HISTORIC ENGLAND
CIVIL & STRUCTURAL ENGINEERING TEAM
SITE VISIT RECORD

KENWOOD HOUSE LADY MANSFIELD'S BEDROOM

Date of Visit 05 /11/2015

Project	LADY MANSFIELD'S	Job No. 19865	Eng. <i>[Signature]</i>
	Bedroom	Date Nov. 2015	Sheet No. Sk 2

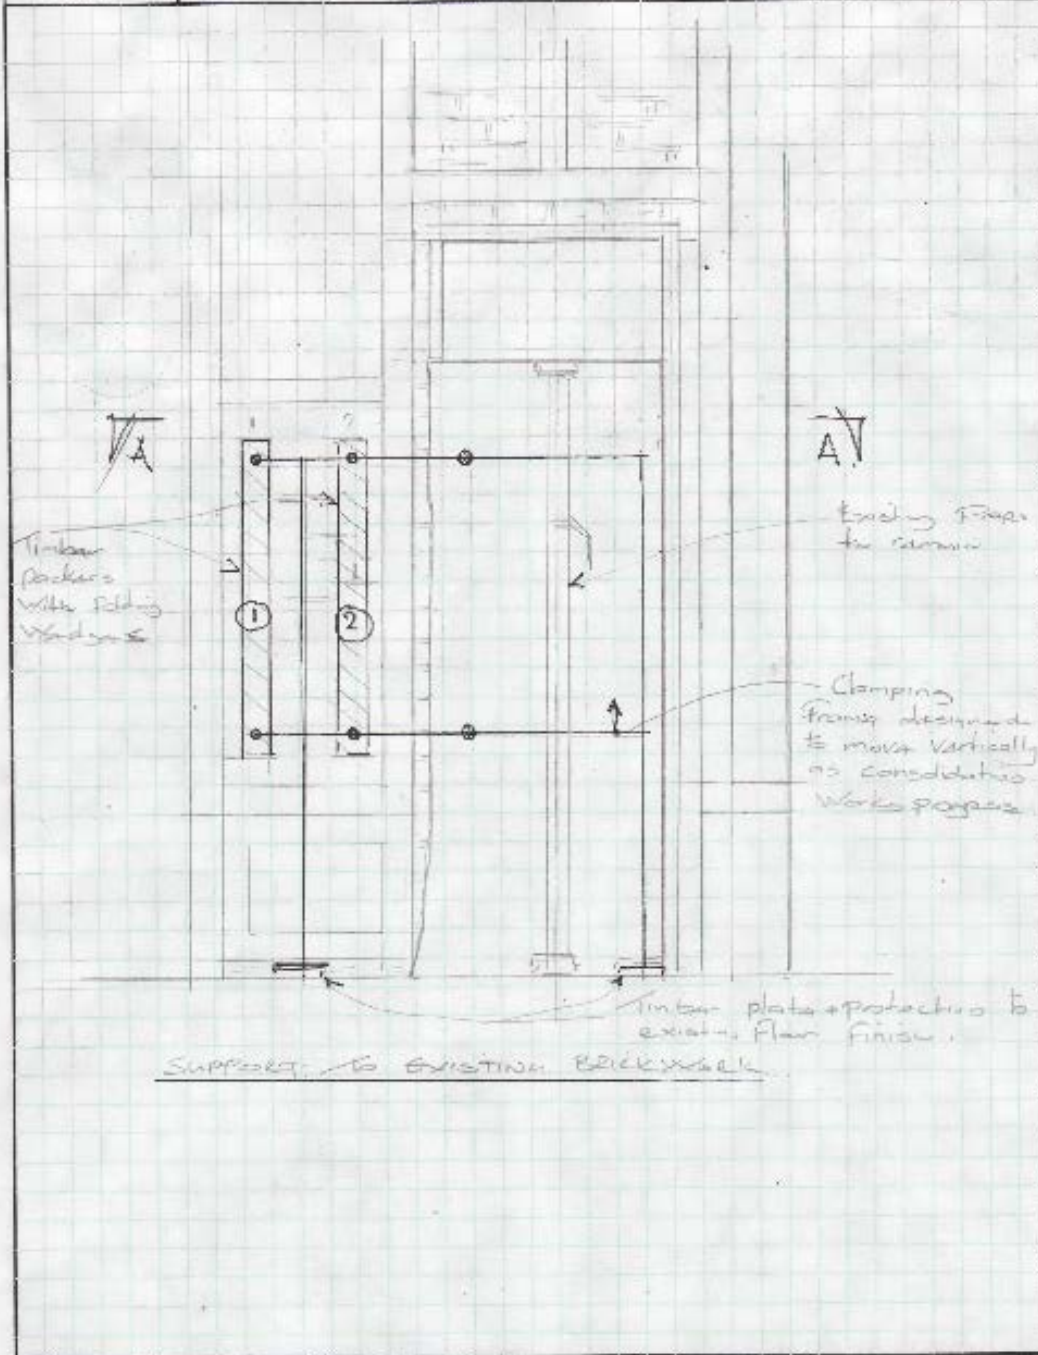
- 1) The existing timber panelling frame is not to be removed until additional temporary support to the facing brickwork is provided. The facing brickwork located in both Lady Mansfield's bedroom and the curators store room are to be held in place. See SK/ 02-03 which indicate the basic principles. The contractor will be required to submit more detailed temporary works information.

← Panelling removed after completion of consolidation works to exposed brickwork.

← Provided temporary frame to clamp wall on both sides
